Environmental Quality Commission

SPECIAL MEETING AGENDA

STAFF REPORT

Regular Business: Make a determination on an appeal for Atlas cedar heritage tree at 1810 Bay Laurel Drive

LEGEND

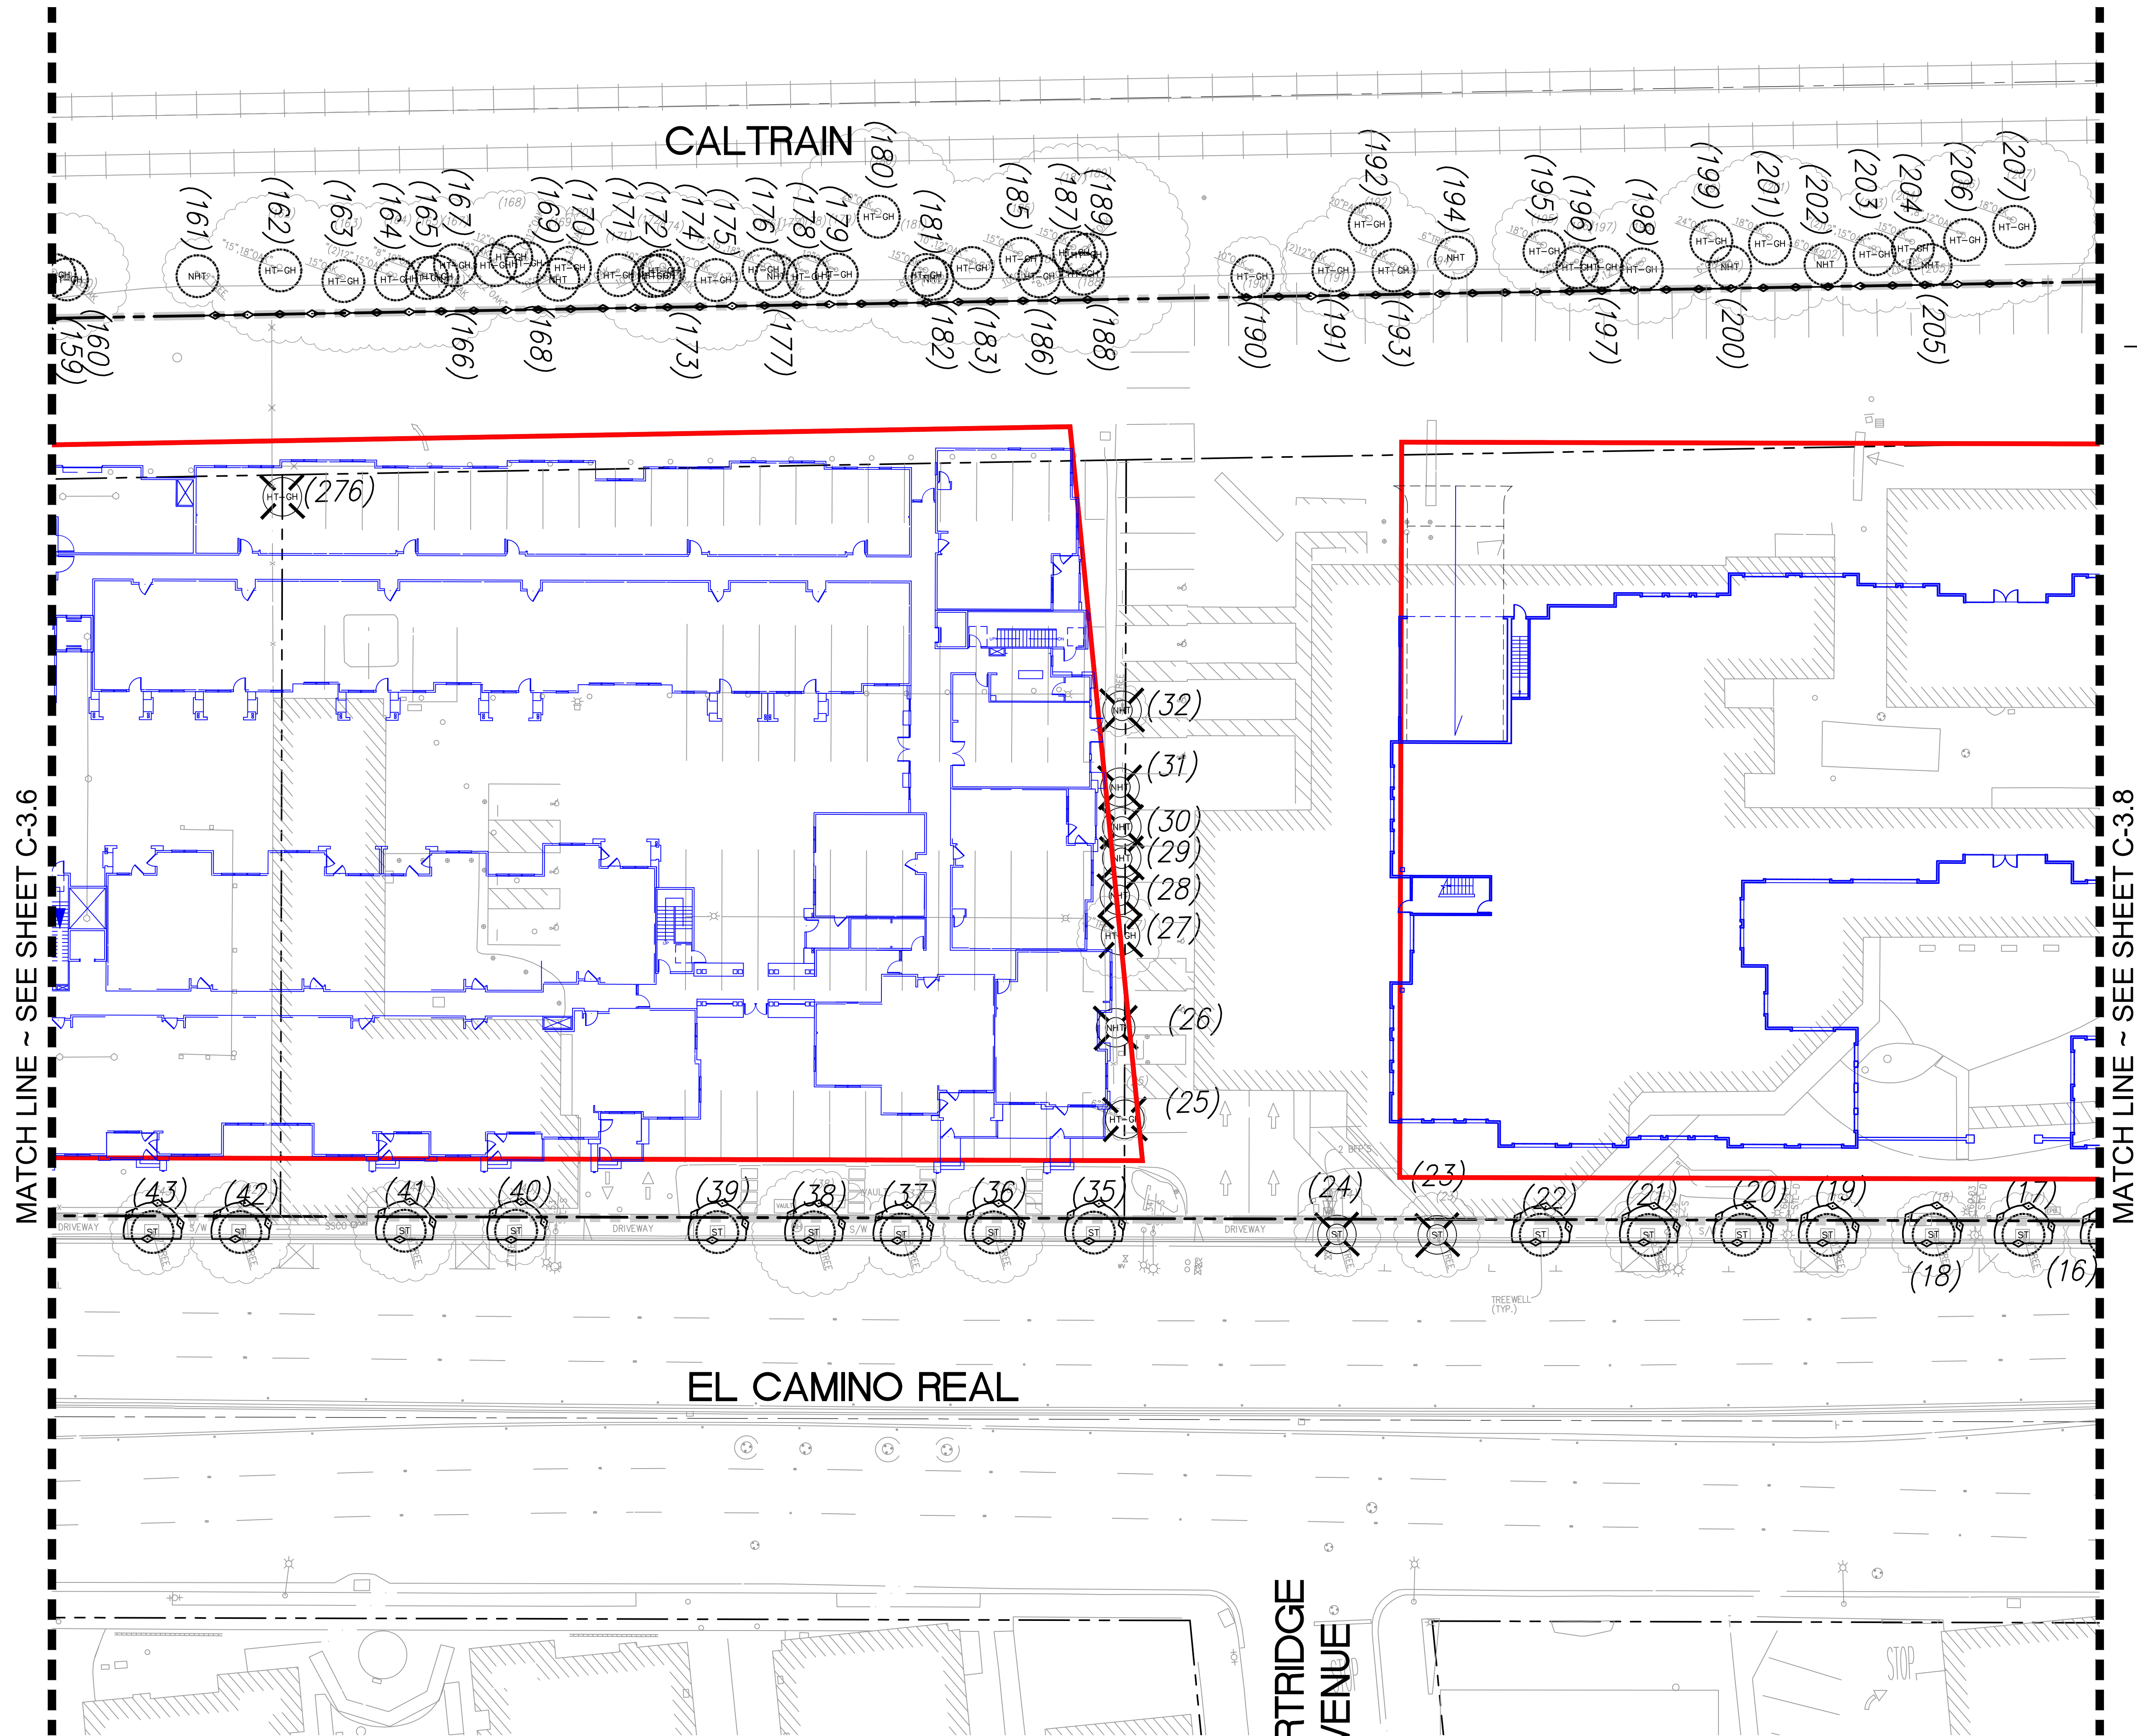
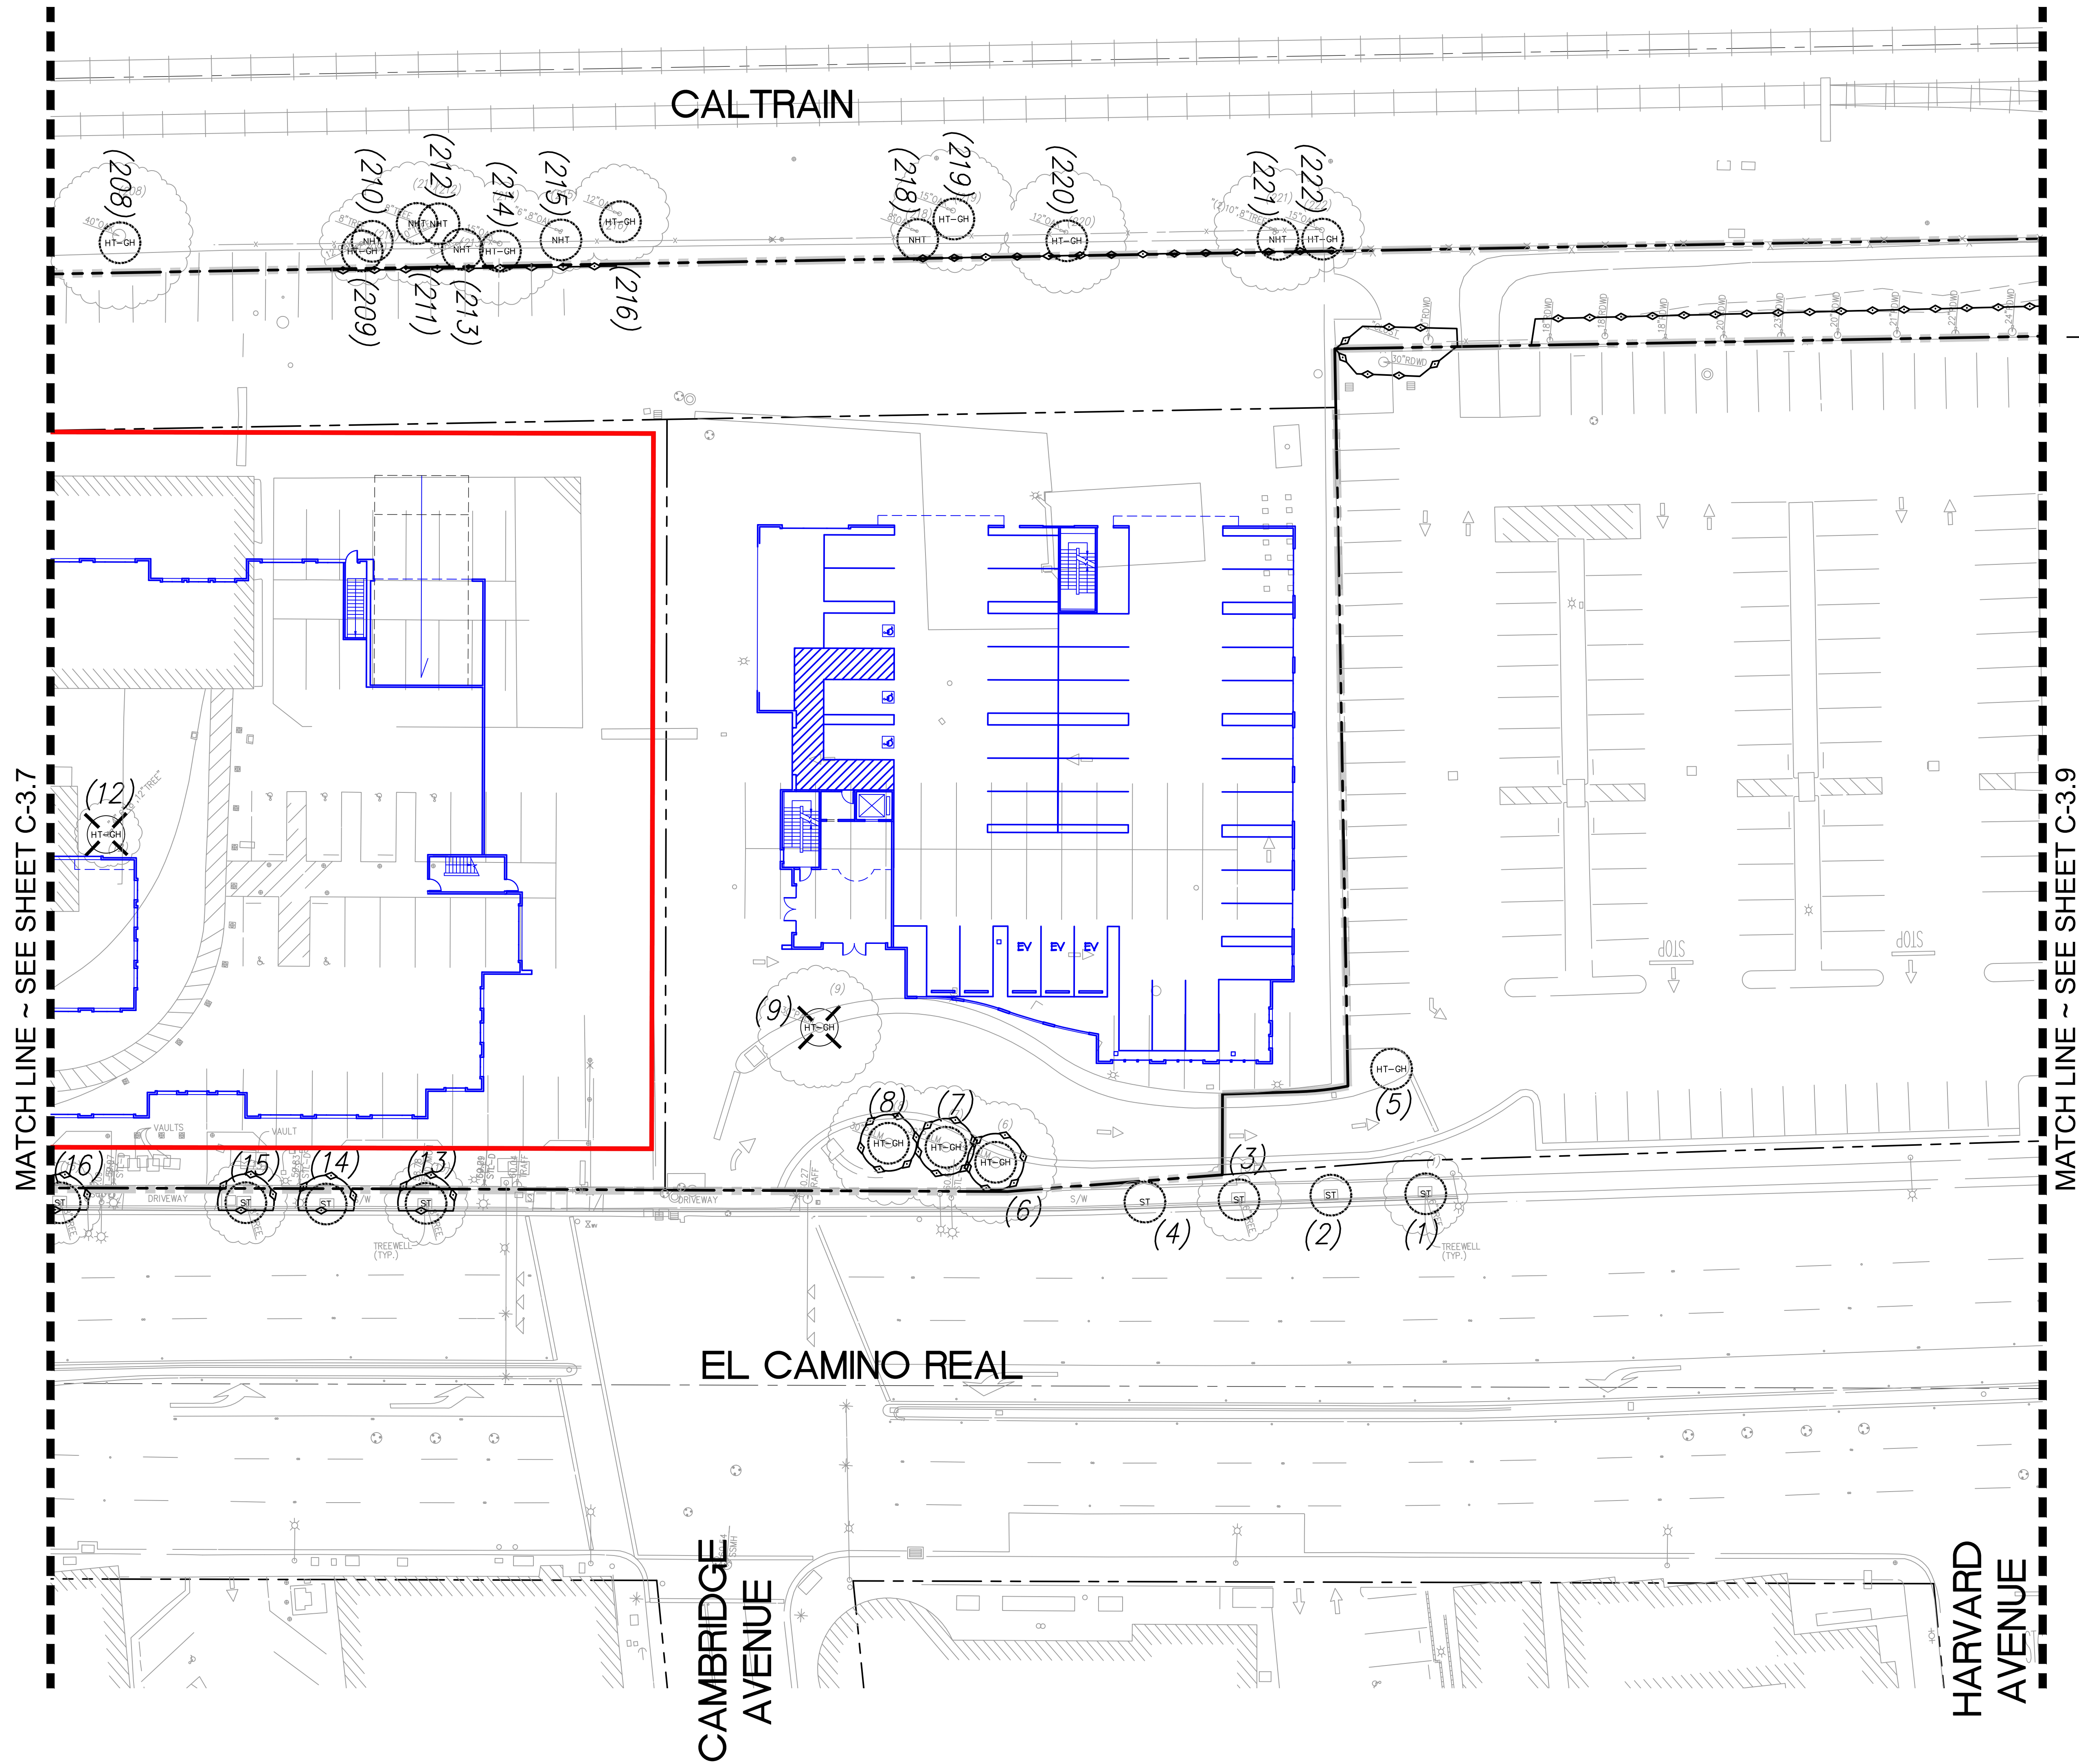
Two London plane street trees along El Camino Real (trees #23 and #24) are shown on the submitted plans as proposed for removal to accommodate a new driveway and curb improvements between the residential buildings and Office Building 2, across El Camino Real from Partridge Avenue. A third London plane street tree (tree #65) is proposed for removal for a new driveway between the plaza and the residential buildings. All three of these street trees are non-heritage in size. While tree #65 is rated as only moderately suitable for preservation by the project arborist, trees #23 and #24 are rated as highly suitable for preservation. Since submittal of the plans, the applicant has indicated that tree #23 could be retained as part of the proposed project. As discussed later in this report, staff will work with the project arborist, before the Planning Commission and City Council hearings, to identify additional street tree planting locations along El Camino Real so there is no net loss in the number of street trees.

In contrast, street trees adjacent to the project site were generally in good condition with a few individual trees in fair condition. The city arborist recommends preserving the two London plane street trees (trees #23 and #24) shown as proposed for removal on the submitted plans, or if preservation is not possible, for the project arborist to work with City staff to identify additional street tree planting locations to avoid a net loss in the number of street trees on El Camino Real. As discussed previously, since submittal of the plans, the applicant has indicated that tree #23 could be retained as part of the project. It should also be noted that the Specific Plan requires a 60-foot building break aligned with Partridge Avenue, on the west side of El Camino Real, making this an ideal location for a driveway. Staff will work with the project arborist, before the Planning Commission and City Council hearings, to identify additional street tree planting locations, either in front of the subject property or at other locations along El Camino Real, so there is no net loss in the number of street trees.
